SUBJECT: Forwards proprietary & non-proprietary response to NRC 990317
 RAI re TR DPC-NE-3005-P, which describes new Duke methodology
 for analyzing Oconee UFSAP Chapter 15 non-LOCA transients &
 accidents. Proprietary info withheld, per 10CFR2.790.

Subject: Oconee Nuclear Station
Docket Numbers 50-269, -270, -287
UFSAR Chapter 15 Transient Analysis Methodology,
Topical Report DPC-NE-3005-P, Revision 1

Responses to Request For Additional Information
DPC-NE-3005P Revision 1

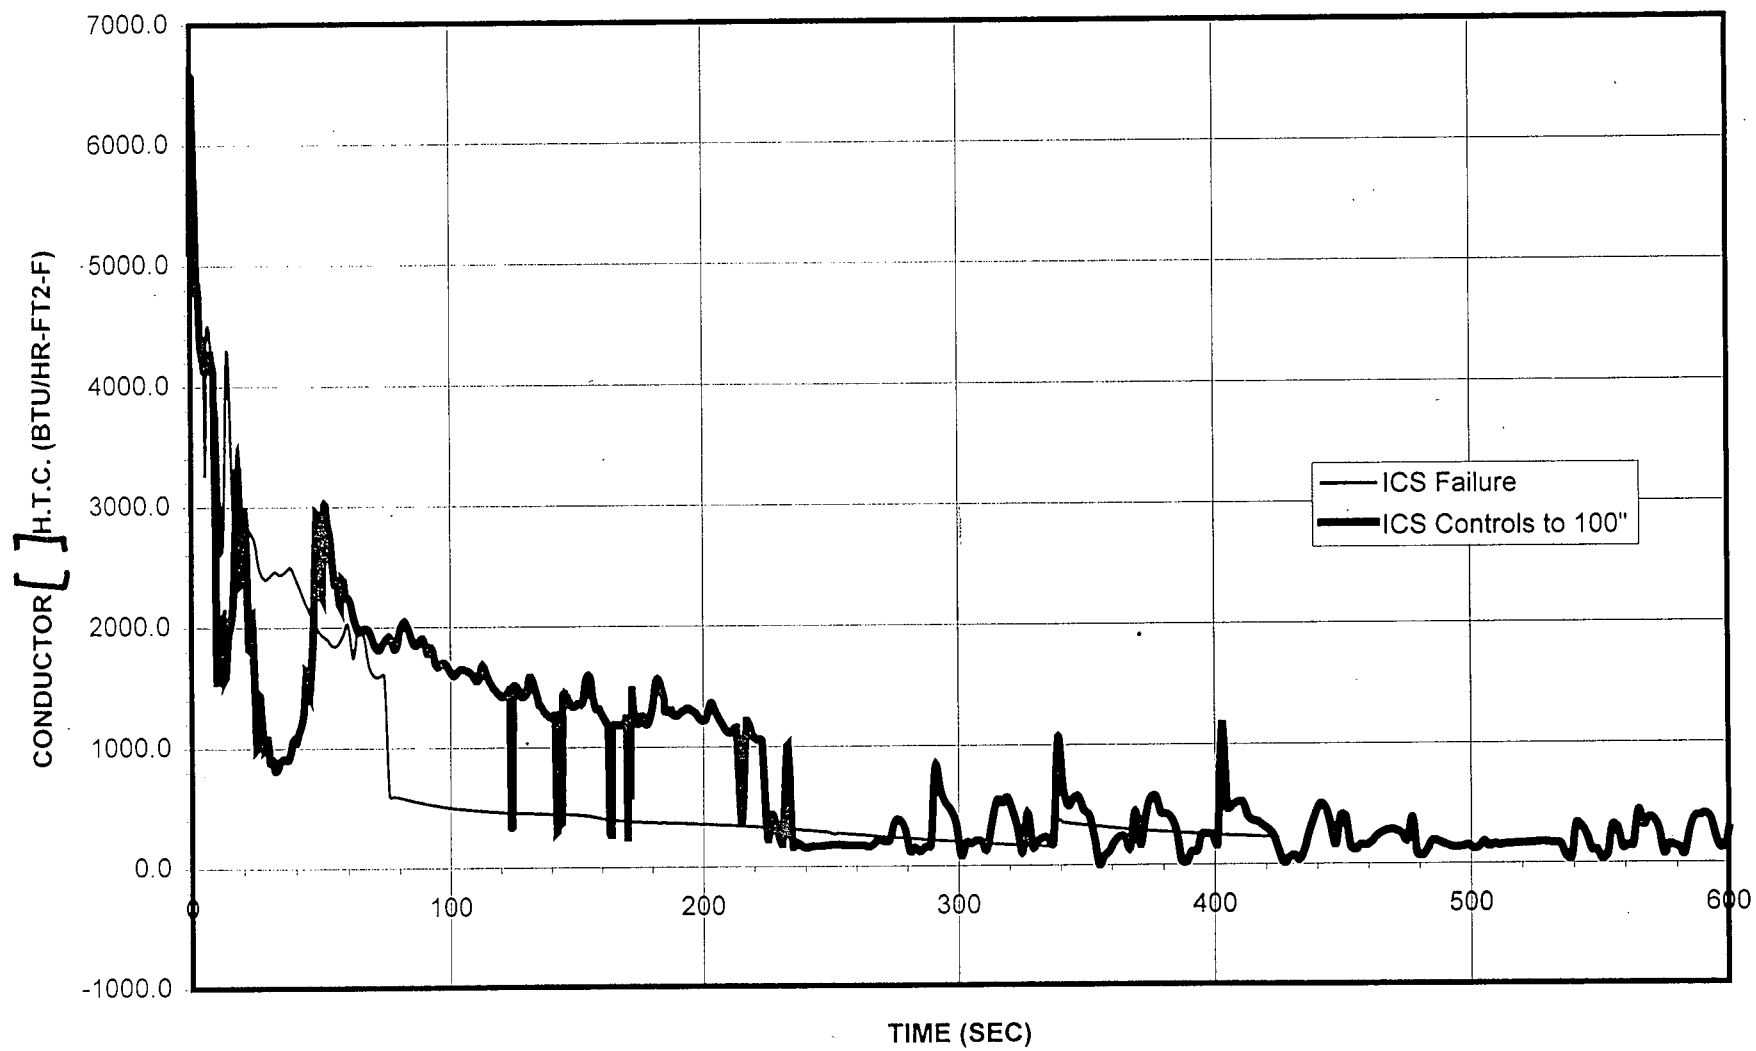
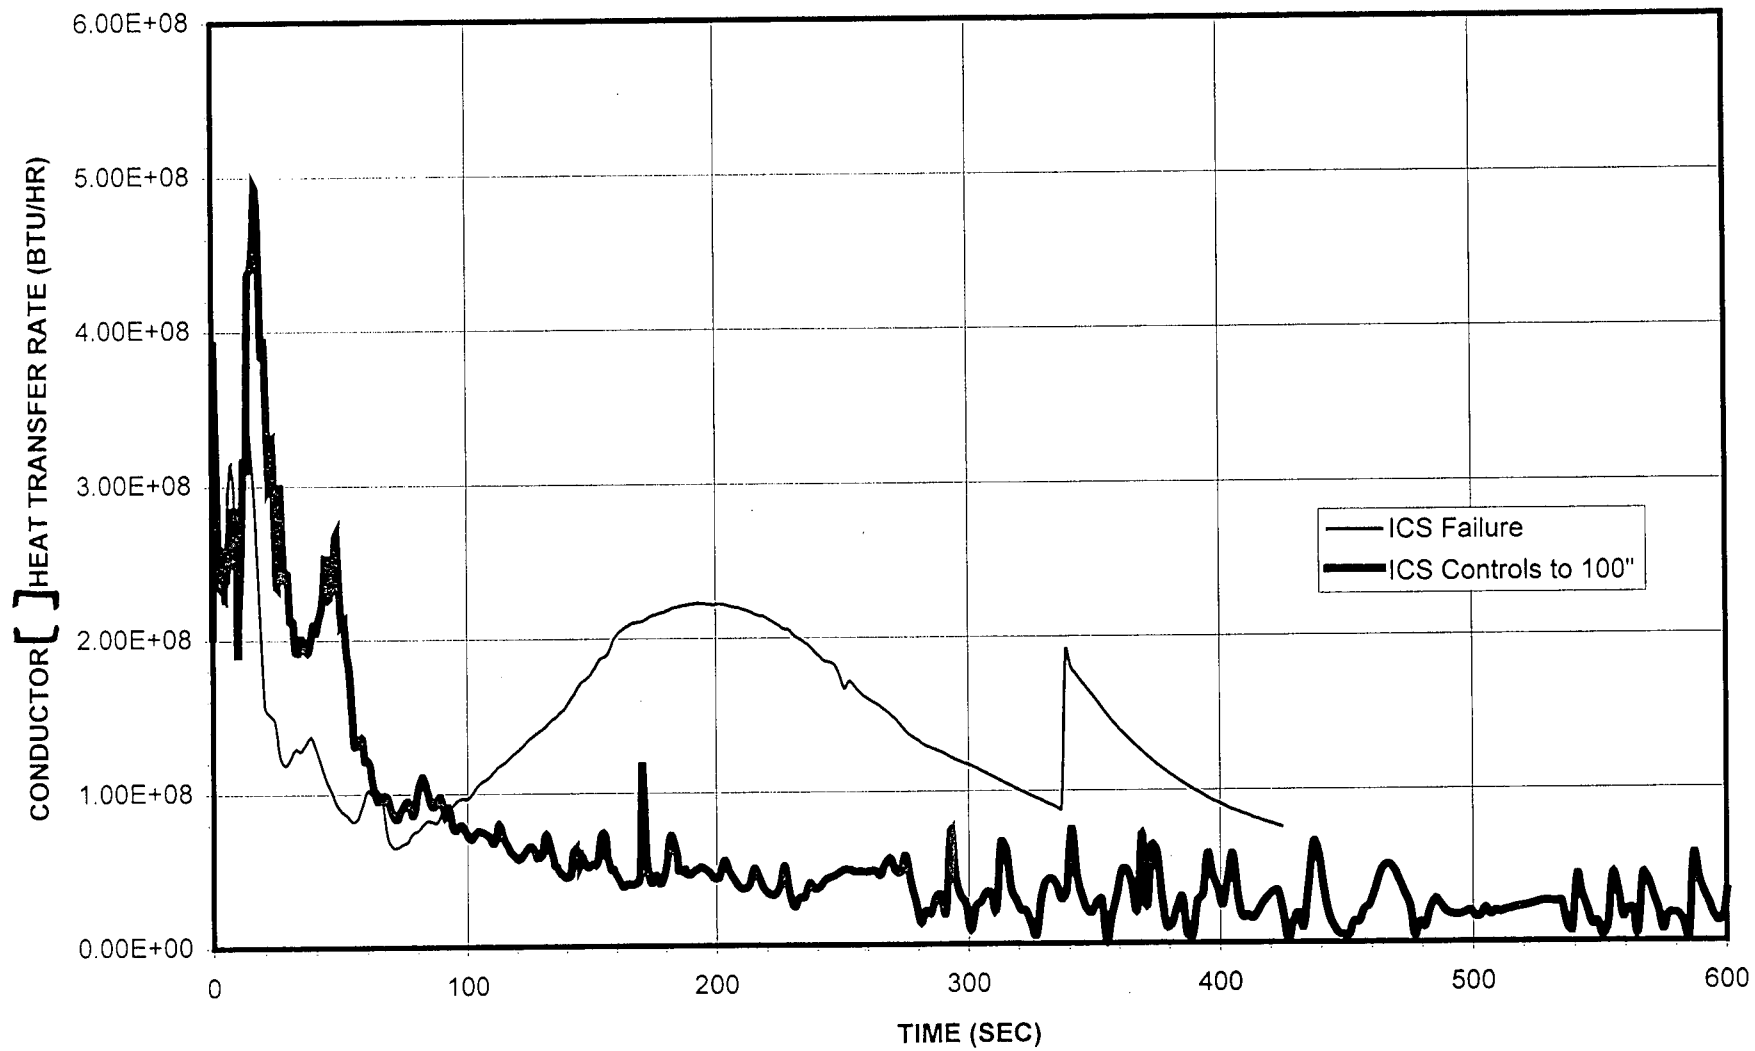
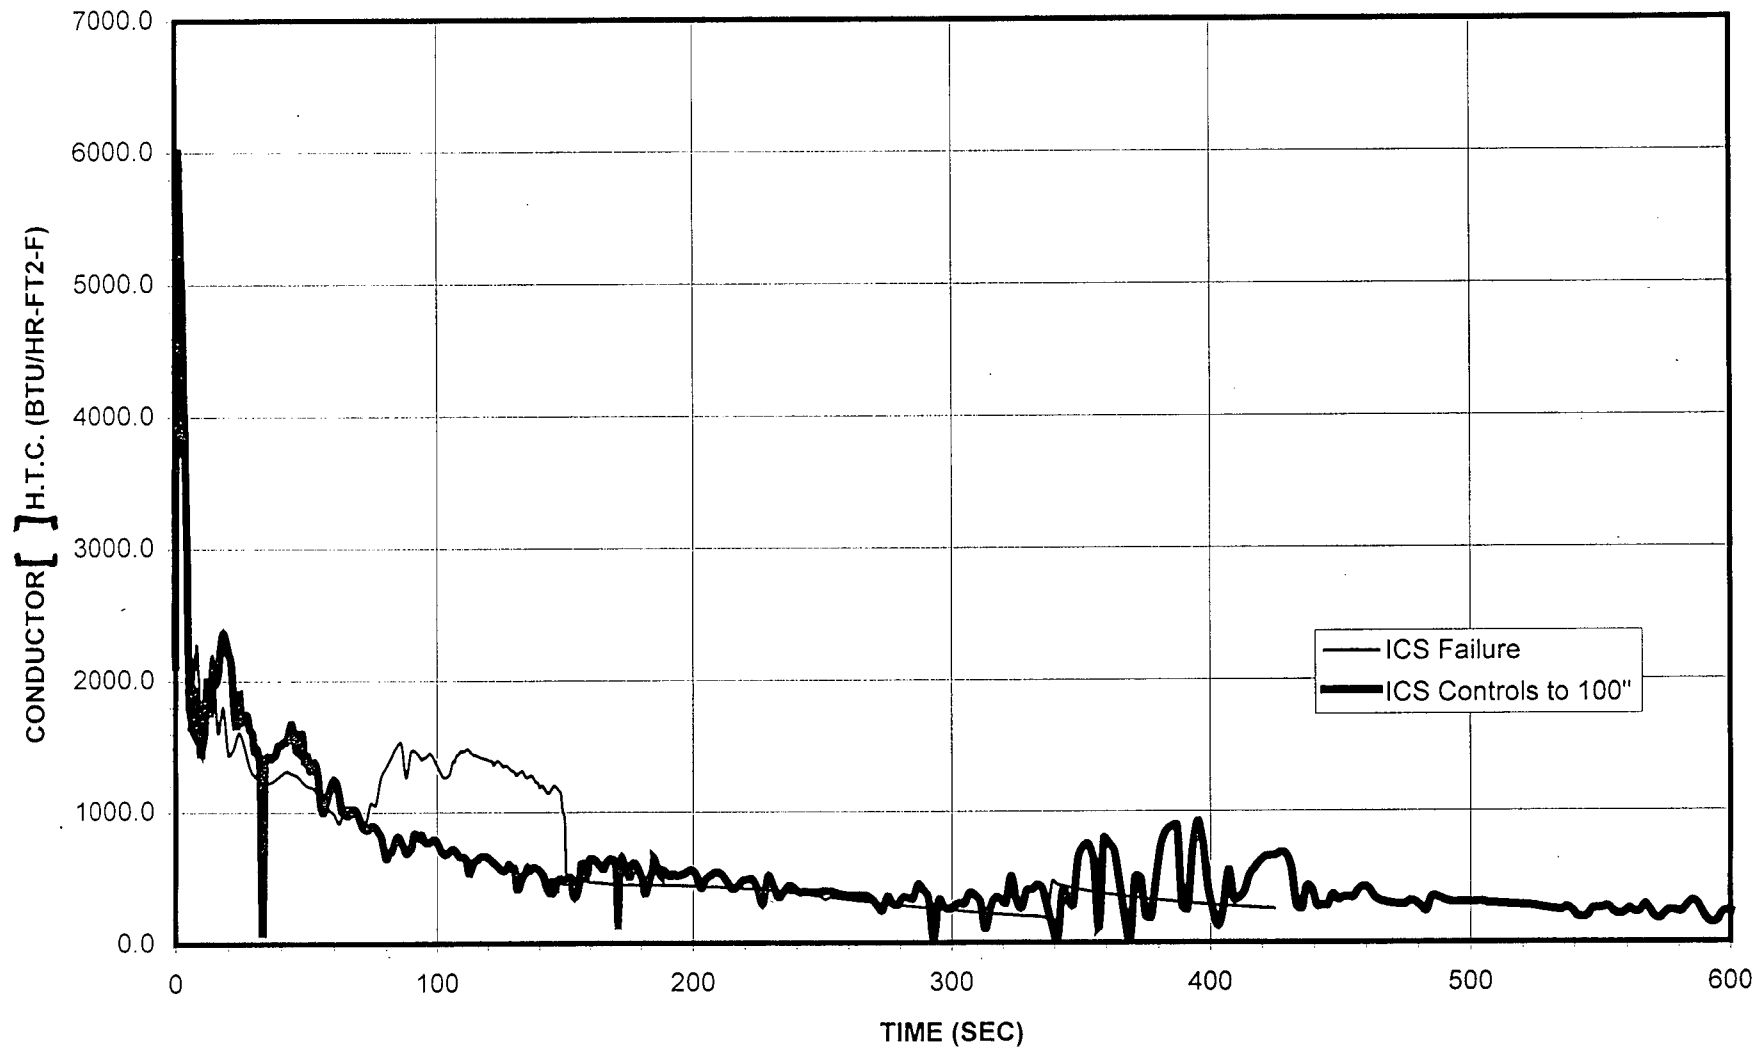
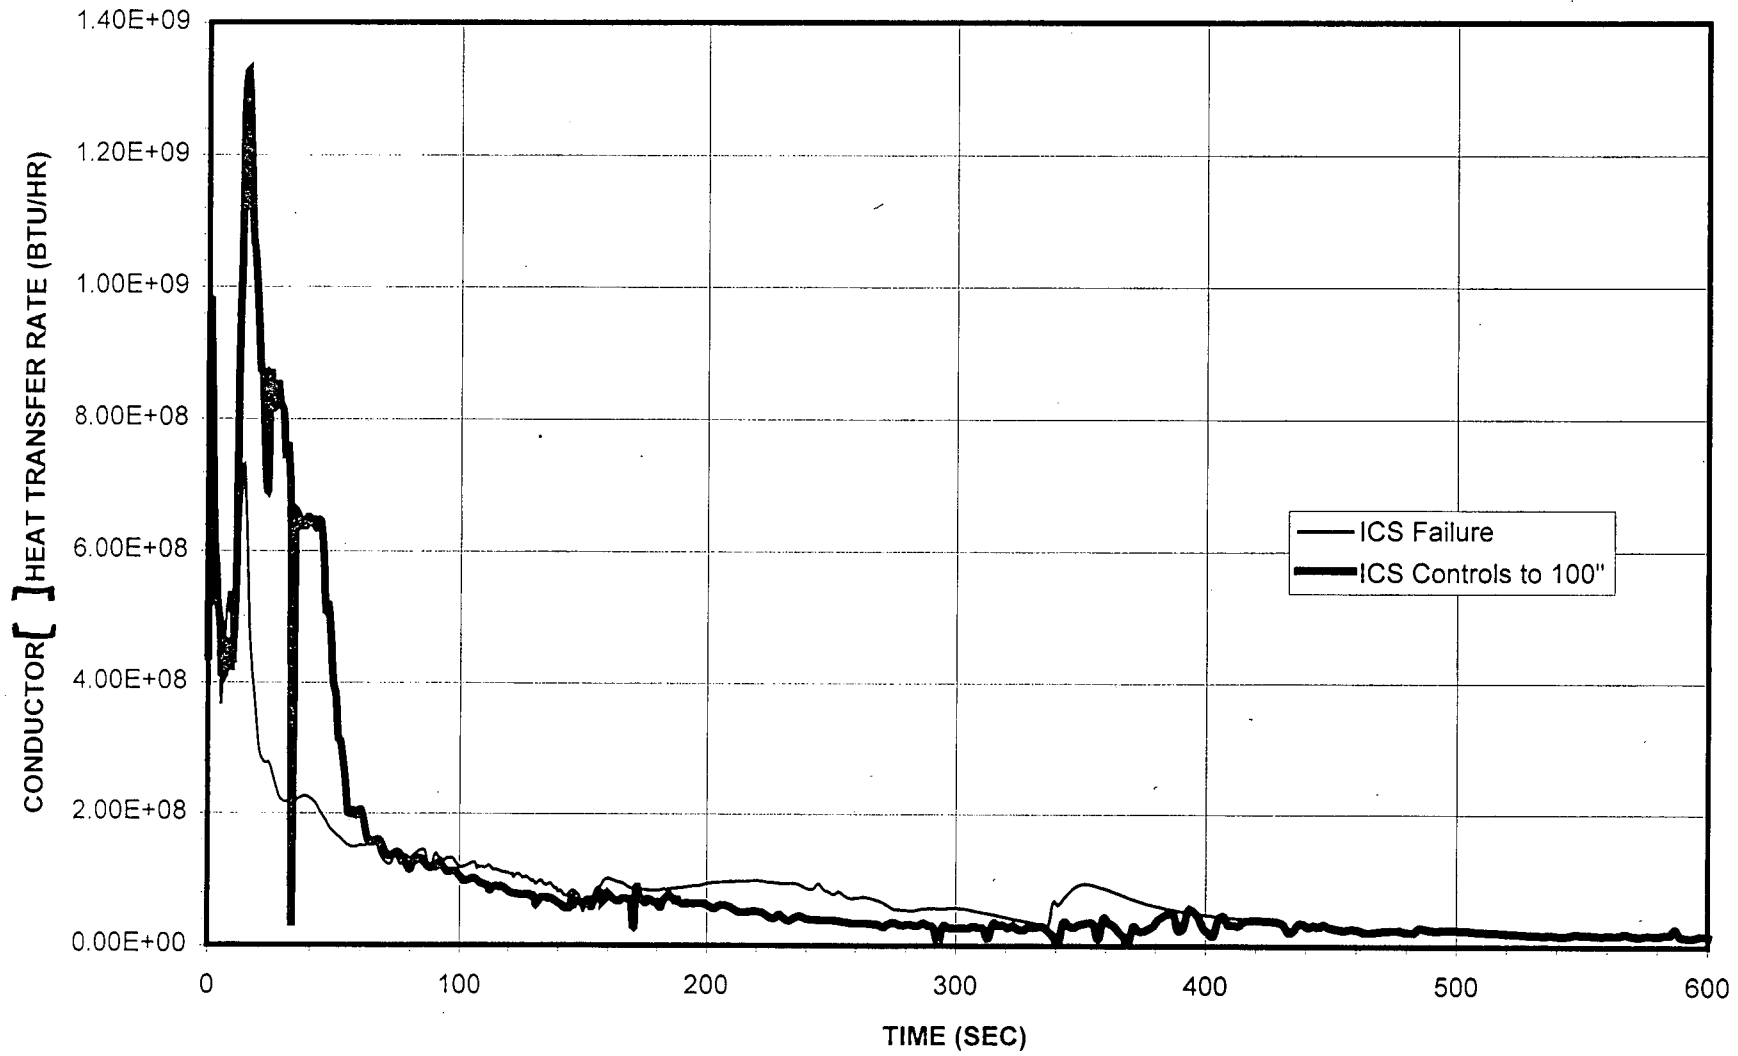
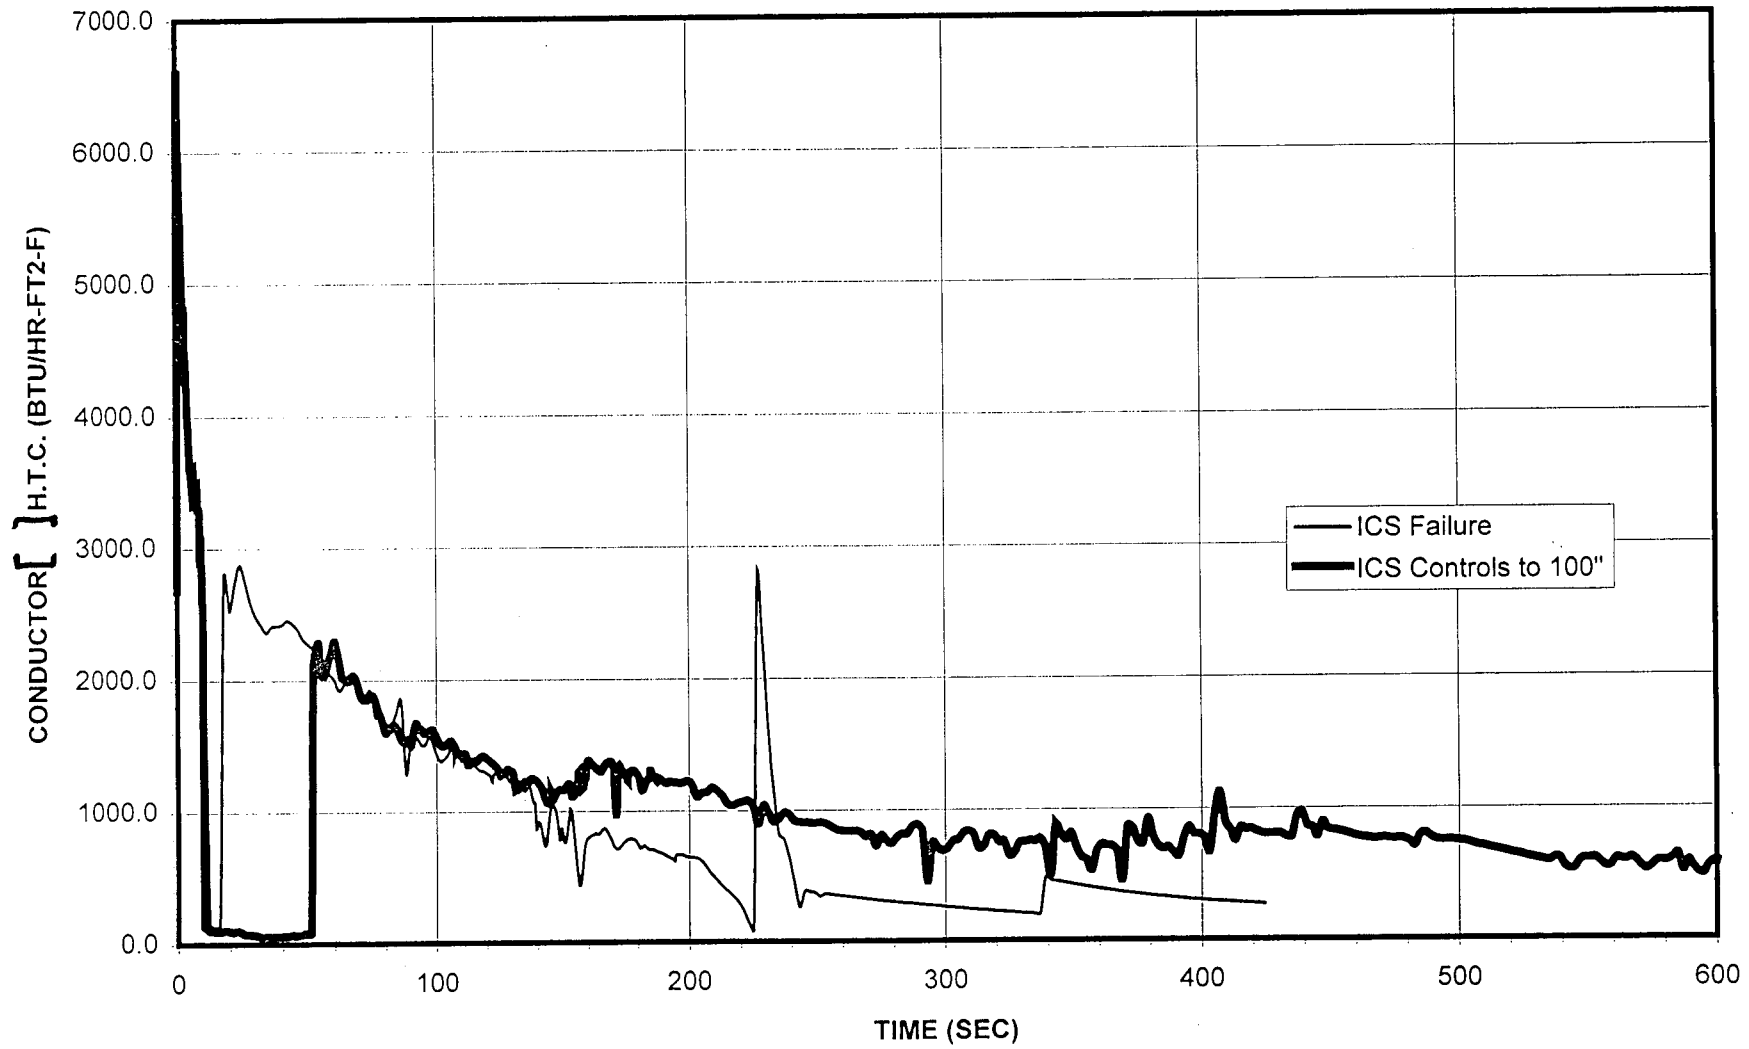
- Q6. Page 15-14 states that the limiting assumption with respect to maximizing overcooling and reactivity addition has been determined by analysis to be the case when the Integrated Control System (ICS) is controlling main feedwater. This case was found to cause more overcooling than the case that assumes failure of the ICS, which would permit unlimited main feedwater addition to the affected steam generator. Provide comparisons of the conditions within the affected steam generator secondary that would cause the ICS operating case to be the worst case. Compare steam generator level, pressure, temperature, and heat transfer coefficients that are calculated by the RETRAN code.

Figures 7-16 show the heat transfer coefficient and the heat transfer rate for [] steam generator tube conductors. The [] were selected to show the axial variation in the predictions. The elevation and height of each conductor above the lower tubesheet are as follows:

Under full power steady-state conditions, the SG tube bundle heat conductors exhibit well defined heat transfer modes. The lower bundle region (Conductors []) contains a relatively large amount of liquid, and is in the nucleate boiling heat transfer mode. The middle bundle region (Conductors []) contains a larger ratio of steam to liquid, and is in the forced convection vaporization heat transfer mode. The upper bundle region (Conductors []) contains steam and is in the forced convection to superheated vapor heat transfer mode. During the blowdown phase of the MSLB, conditions within the SG undergo a violent change. The decompression of the steam generator causes liquid in the lower region of the tube bundle and in the downcomer to be transported to higher elevations within the tube bundle by entrainment in the high velocity steam flow. Due to the severe pressure reduction, flashing occurs in the downcomer and results in reverse flow through the aspirator port. The reverse aspirator port flow contributes to a second boiling region in the upper tube bundle. Upper tube bundle conductors, which are at the hottest temperatures, are

periodically quenched with slugs of entrained liquid. For the ICS failure case, the SG gradually fills with liquid after the initial blowdown and experiences less boiling. The accumulation of subcooled liquid as the overfill progresses results in RETRAN predicting the forced convection to subcooled liquid heat transfer mode. For the ICS controlling to 100 inches case, MFW flow is unstable as the ICS attempts to maintain the level setpoint. During periods of high MFW flowrates the liquid levels within the tube bundle increase, causing heat transfer behavior similar to the initial blowdown. During periods of low MFW flowrates, the hotter tube bundle regions dry out. As the temperature differences between the primary and secondary decrease as the analysis progresses, heat transfer coefficients and rates decrease for all conductors for both cases. The integral effect of the heat transfer predicted for each tube bundle conductor is described in the preceeding paragraphs. The overall heat transfer rate, and therefore the consequences of the two MSLB cases are quite similar, with the case with ICS controlling to the level setpoint slightly more limiting.
